# SERVICE BULLETIN

April 25, 2000

# IDLE SPEED SETTING PROCEDURE FOR FLTRSEI WIRING DIAGRAM FOR FLTRSEI

M-1101

Illustration. Induction Module

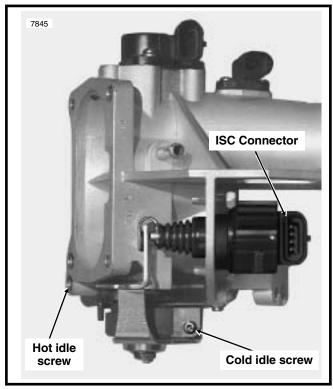
Normally both cold and hot idle speeds are factory set and should not require adjustment. We recently learned however, that some early production SCREAMIN' EAGLE® ROAD GLIDE®, FLTRSEI vehicles were shipped with an improperly adjusted hot idle.

Due to the performance camshafts and the 1550 Stage 2 calibration, the throttle openings required to maintain the desired hot and cold idle speeds differ from the 1450 engine. Therefore a different idle speed setting procedure is required. The following procedure will also reduce potential intake seal leaks because there is no need to run the engine without the air cleaner assembly to support the induction module.

- 1. Refer to Section 9 of the FLT Service Manual, remove air cleaner assembly including backplate from engine.
- 2. Remove right saddlebag and right side cover. Connect Scanalyzer to data link connector. Cycle ignition switch ON and OFF to insure idle speed control actuator (ISC) is in proper position.
- 3. See Illustration. Unplug connector at the ISC.
- 4. Turn ignition switch ON and engine stop/run switch to RUN position.
- 5. Select the "Data Monitor" option on the Scanalyzer and scroll down to "TP voltage".
- 6. Note and record "TP voltage" (this is hot idle setting and should be approximately 0.7 volts. Back out (turn counterclockwise) hot idle screw approximately 2 turns. "TP voltage" should now be dependent on cold idle screw and should be between 0.64 and 0.68 volts. If necessary, adjust the cold idle set screw to obtain that proper cold idle "TP voltage" of 0.64 0.68 volt.

To gain access to cold idle screw in step 6, gently open throttle. DO NOT allow throttle to "snap" shut. This could cause the ISC to move and change the TP voltage. Roll throttle closed gently.

- 7. Return hot idle speed screw to approximately 0.7 volts.
- 8. Turn ignition switch OFF and wait approximately 10 seconds for ECM relay to disconnect. (ISC will stop in the extended position and the Scanalyzer screen will display "No response").
- See Illustration. Reconnect connector at the idle speed control actuator.
- 10. Install air cleaner backplate.
